Project Number: EABPRJ ABCDEF
Project Name: Demonstration Project
Facility: Toontown Recreation Center
Address: 100 E. Main Street, Building A
Toontown, Texas 78787

Project Description: New theater complex for cartoon characters
Start Date: January 19, 2012
Estimated Completion Date: December 7, 2012
Estimated Cost: \$10,000,000

Plan Review Report

Figure 306.2 Toe Clearance

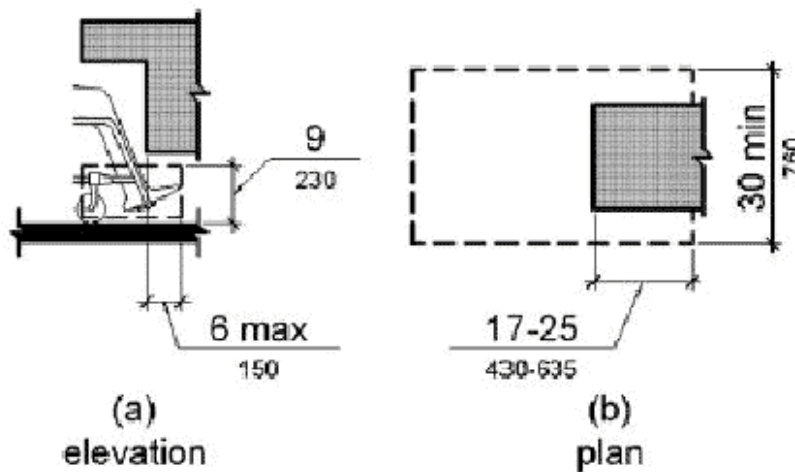
Unacceptable: 306 Knee and Toe Clearance.

306.2.3 Minimum Required Depth.

Where toe clearance is required at an element as part of a clear floor space, the toe clearance shall extend 17 inches (430 mm) minimum under the element.

Comment: The depth should be at least 6 inches in the toe area.
